2022.0234
8 July 2024 – Original

RE: Proposed One School Global Campus, Lot 1 DP527491, Magpie Hollow Road, South Bowenfels, 2790

In response to the Request for Information from Lithgow City Council, dated 7 June 2024 please see herein Calare Civil's response to point 3c – item d, and point 3e regarding the stormwater discharge location and the classification of this site as flood prone land respectively. This letter has been informed by a review of aerial imagery, LiDAR survey data from the NSW Spatial Services Portal, Lithgow City Council's Guidelines for Civil Engineering Design and Construction dated February 2012, and the Lithgow Flood Study Review, prepared by Lyall & Associates in May 2017. To resolve Council's concerns, each point has been assessed in detail and our findings and recommendations are provided below.

Plate 1: The 1% AEP Flood Extents as per the Lithgow Flood Study Review (2017) with an overlay of the proposed works.

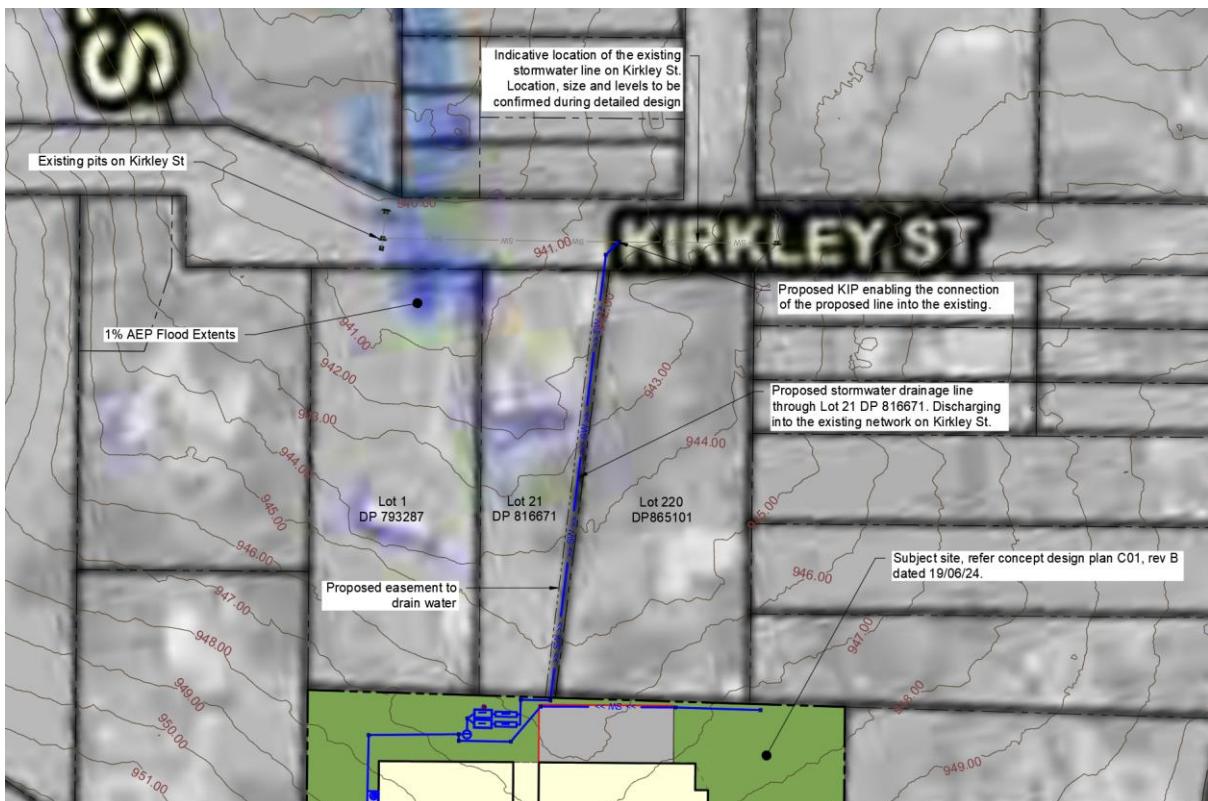
Point 3c – Item D: The northern stormwater discharge outlet needs to be above the flood level.

- The new pit into which this line will discharge will sit outside of the 1% AEP Flood Extents as shown in Figure 6.4 of the Lithgow Flood Study Review. A snippet of this figure is presented below in **Plate 1** which also depicts an overlay of the proposed stormwater line, potential connection location and the indicative location of the existing stormwater line on Kirkley St. It is noted that there is approximately 300mm of ponded water to west of the proposed connection of which is associated with a sag point on Kirkley St; the surface level at this sag point is approximately 940m AHD. The surface level at the proposed connection point is approximately 941.5m AHD meaning there is a 1.5m elevation difference between the two locations, thus the proposed line will discharge freely into the new pit for the design event.

Plate 2: The Flood Extents for the PMF as per the Lithgow Flood Study Review (2017) with an overlay of the proposed works.

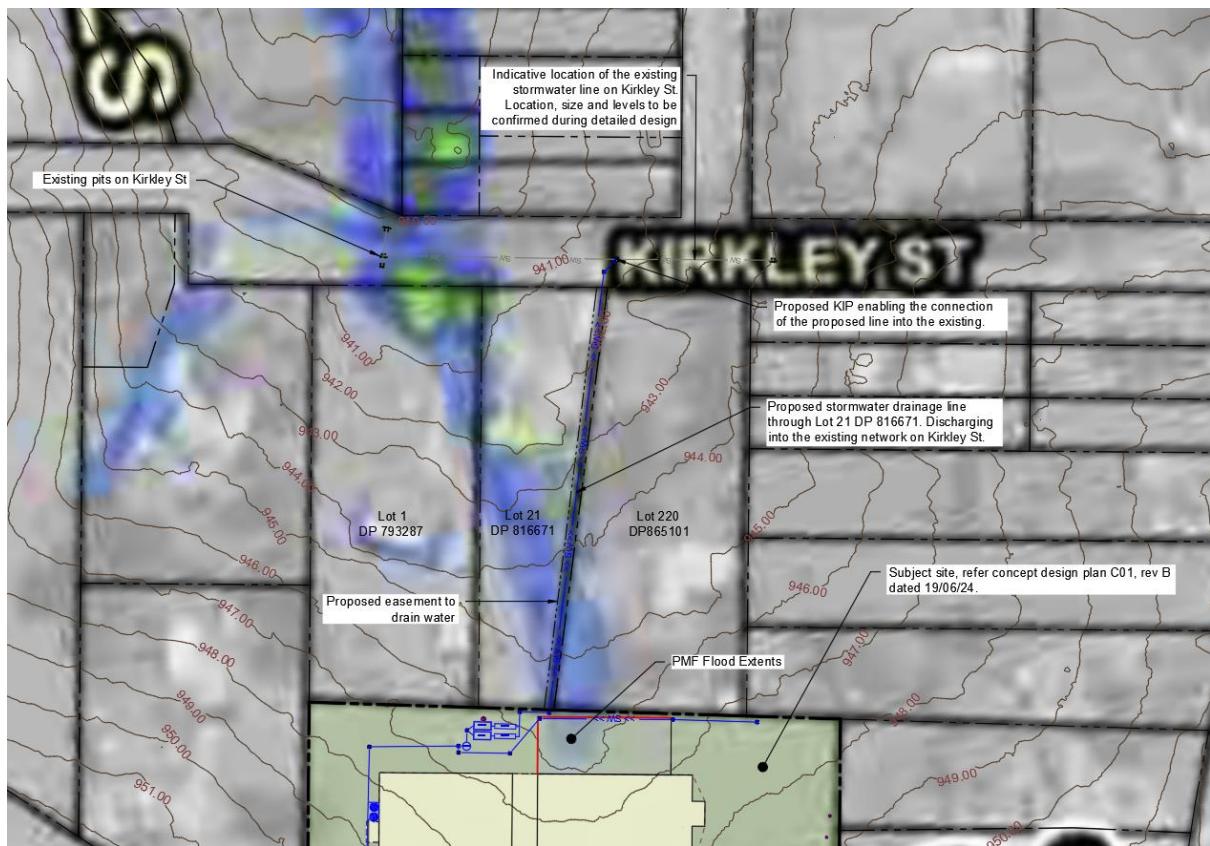
Item 3e: – Pursuant to Council’s Flood Model 2021, the site is affected by minor flood on the northern boundary. As such, a Flood Impact Statement shall be prepared by a suitably qualified and experienced consultant and submitted to Council for review.

- From Figure 6.6 of the Lithgow Flood Study Review (2017) it is suggested that a very small portion of the site along the northern boundary experiences some minor inundation of up to 200mm in depth during the Probable Maximum Flood Event (PMF), the extent of which is presented in **Plate 2**. With the proposed site grading and construction of the retaining wall to provide a flat surface for the proposed outdoor sports area, this inundation will not impact upon the proposed facility. Furthermore, the PMF is the theoretical maximum flood and is therefore the rarest event, one that will likely never occur; it is only used to define the maximum possible flood extents based on the Probable Maximum Precipitation (PMP) and is not something that can be designed for. As such this possible inundation should be disregarded when considering manageable flood impacts.
